TRAFFIC IMPACT STUDY

The Dover Transit Center Water and Queen Streets

RE: Dover Transit Center

As requested Orth-Rodgers & Associates (ORA) has reviewed two additional concept plans associated with the proposed Dover Transit Center. Our analysis for the previously proposed concept plans were compiled in a report dated January 30, 2007. That report included an in-depth traffic analysis of the proposed facility and included specific information regarding items such as peak hour trip generation, trip distributions, and vehicular levels of services. It should be noted that although new conceptual plans are being developed, the general characteristics of the proposed site remain the same and most of the technical data found in the January 30, 2007 report remains valid. As such, this memorandum is meant to supplement, not replace, the previously completed efforts.

Concept 2

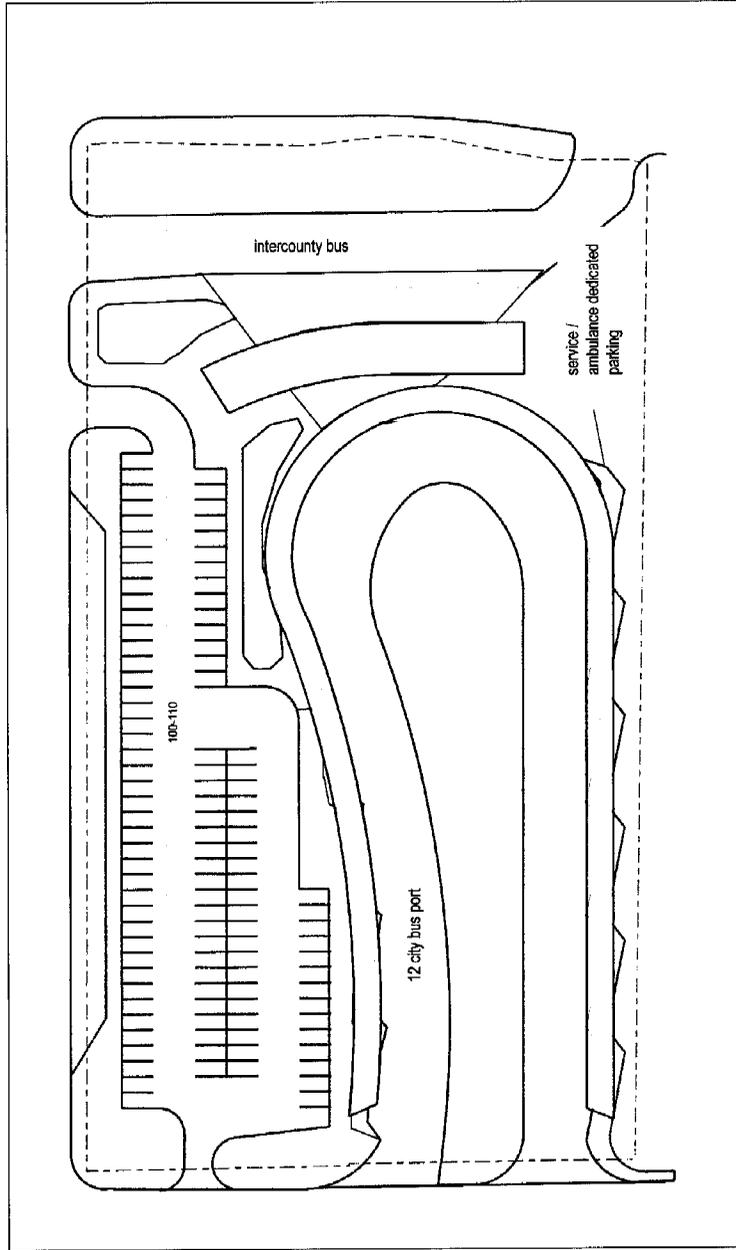
- The concept shows the Intercounty/Greyhound busses gaining access to the site via a driveway on Water Street, just east of the Queen Street intersection. It should be noted that left turn access into this driveway would be problematic. Due the traffic signal at the adjacent intersection, traffic will routinely backup on Water Street blocking this access point. ORA does not recommend having this access point near the intersection. However if Concept 2 is selected, this access point should be planned to accommodate only entering right turns.

- On Queen Street, there is an access point at the southern end of the site that would serve the Intercounty/Greyhound busses as well and the private ambulance service. As previously noted Queen Street has the highest amount of traffic in the area and would be the most difficult access point for busses. During the peak hour, average delays of more than 30 seconds per vehicle will exist and significant queuing of exiting busses may occur. If Concept 2 is selected, this access point should be designed to accommodate exiting right turns only.

- If the Intercounty/Greyhound busses are restricted to right turns out at Queen Street, DART should closely review the routes in which those busses will be assigned. Currently most busses run along Water Street at some point during each run and directing those busses southbound on Queen Street may significantly increase the travel time and distance for those busses.

- If Concept 2 were carried forward, another potential option would be to reverse the direction of flow for intercounty busses. If an adequate turning radius can be provided, the better option may be to have the larger busses turn right into the site from Queen Street and exit by turning right out of the site onto Water Street.

- As previously noted, some consideration should be given towards minimizing the total number of “curb cuts” along the site’s frontage. Along West Street, there are three driveways in very close proximity. We recommend redesigning the city bus loop road so that both the entering and exiting movements are made a single

driveway location. This change will help separate and distinguish the bus access and parking lot access, it will reduce the number of conflict points for passing motorists as well as pedestrians and it will reduced the potential of having motorists enter or exit at the wrong locations.

- When compared with Concept 1, Concept 2 provides a more defined and better accessible parking component. However, the total number of parking spaces appears to be less.
- Along Water Street the parking lot access point seems to be too close to both the signalized intersection and the proposed bus access point. We recommend moving the parking lot access to a mid bock location to avoid having vehicular queues regularly block the driveway.
- The plan appears to show a drop off area along Water Street curb line. Compared to other concepts, this drop off area is notably far from the transit center building. If the parking lot access point were moved away from the signalized intersection, this would allow for the drop off area to be situation east of the parking lot access point and closer to the building.
